June 19, 2006

Supplement to HAC Test Report for Motorola portable cellular phone (FCC ID IHDT56EL1)

There was a request for additional information regarding Motorola's HAC Test Reports for Motorola portable cellular phone (FCC ID IHDT56EL1). The requested information is addressed below in the same numbering sequence received.

The broadband signal utilized is shown in the following plot:

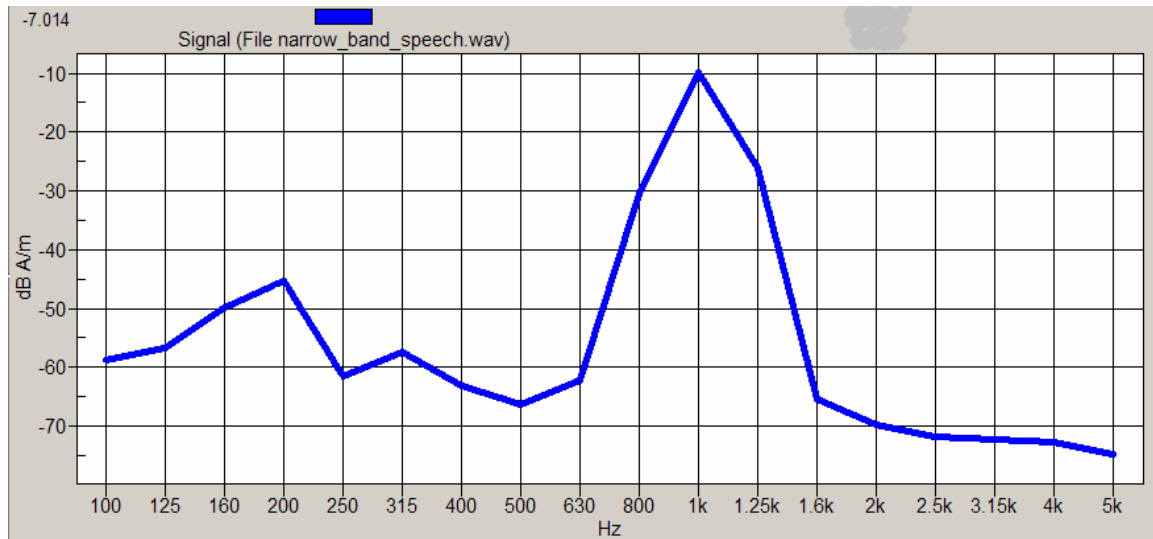
Please provide more details of how the systems make all measurements such as timing, averaging, spectral processing, measurement sequence, and mathematical processing. For frequency response please discuss how input signal level is measured, and how the input source's spectral response is accounted for.

The DASY4 system corrects for the spectral response after measurement since it knows the spectrum of the input signal. However, please note that for the signal that we use, the spectrum is flat when measured in 1/3 octave bands, covering the range up to 3kHz.

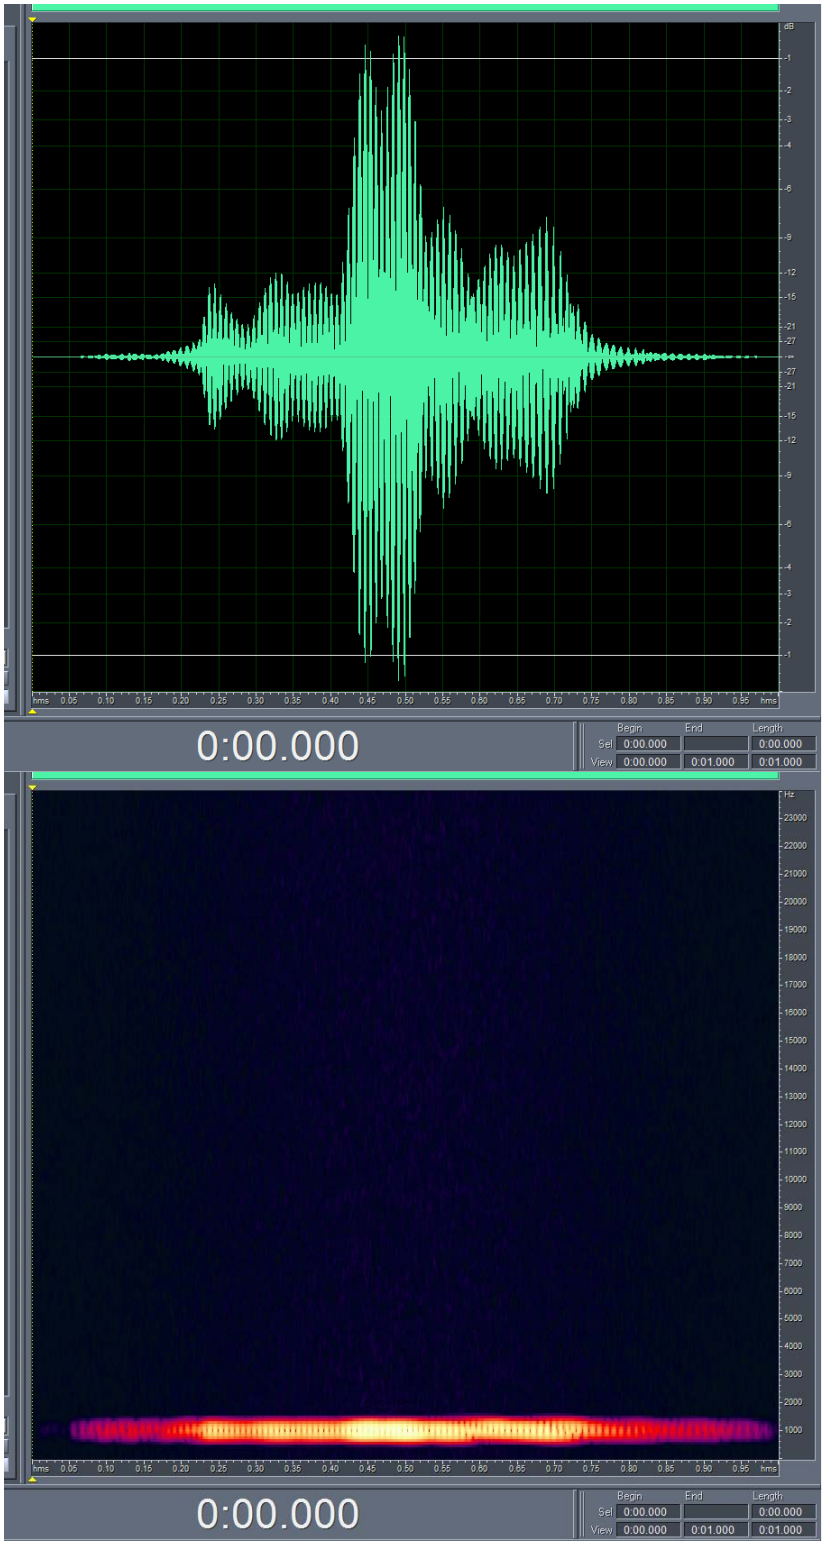
Please provide details for the -28.28 V/ (A/m) probe sensitivity shown in Graph 1. Is this for a 1 KHz CW signal or broadband? Does Speag have additional probe calibration factors that are also accounted for? The graphs mention an internal cal factor. Is the voltage shown in the graph that measured over the 10 ohm shunt resistor or elsewhere?

Is this for a 1 KHz CW signal or broadband? The -26.28 V/ (A/m) sensitivity is for 1 KHz sine signal

Does Speag have additional probe calibration factors that are also accounted for? The sensitivity includes both probe sensitivity and pre-amplifier sensitivity. It is the total calibration, and there are no additional probe calibration factors.

The graphs mention an internal cal factor. Internal voltage measurements are used to calculate sensitivity of -26.28 V/ (A/m).

$$\text{Formula: } 20 * \text{Log} (1.19135 / (2.45397 / 0.1)) = -26.28 \text{ V / (A/m)}$$

Is the voltage shown in the graph that measured over the 10 ohm shunt resistor or elsewhere? The voltage into the Helmholtz coil is across the shunt resistor.

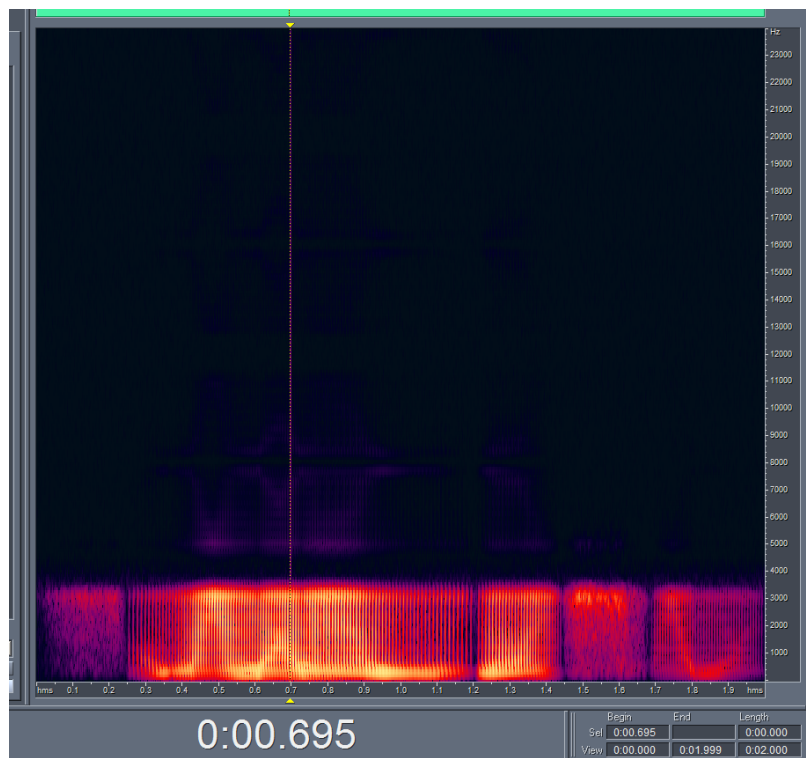
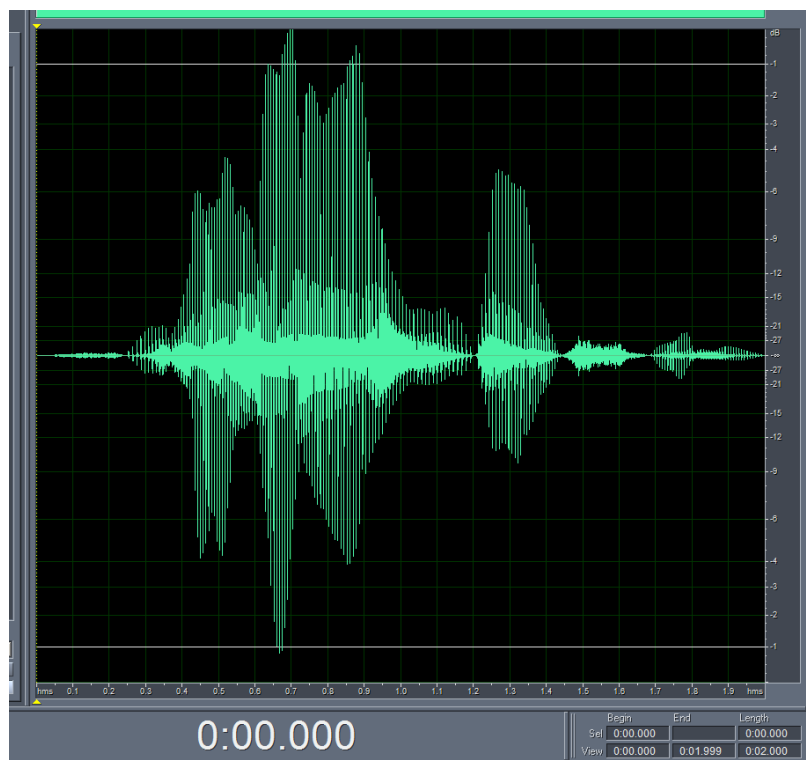
Please provide full details of the source audio signals for all aspects of the test. Please include spectral and temporal characteristics and any special processing requirements used in the system such as averaging.

Here is the temporal response of the narrow band signal. The signal is one second of the standard P.50 speech band limited to the ANSI 1kHz 1/3 octave band. The signal is Hann windowed to ensure continuity of the signal.

Here is the temporal response of the 300Hz-3kHz broadband signal. The signal is a 2 second segment of the standard P.50 speech that is equalized flat (for ANSI 1/3 octaves) over the 300Hz to 3kHz range. The signal is Hann windowed to ensure continuity of the signal.
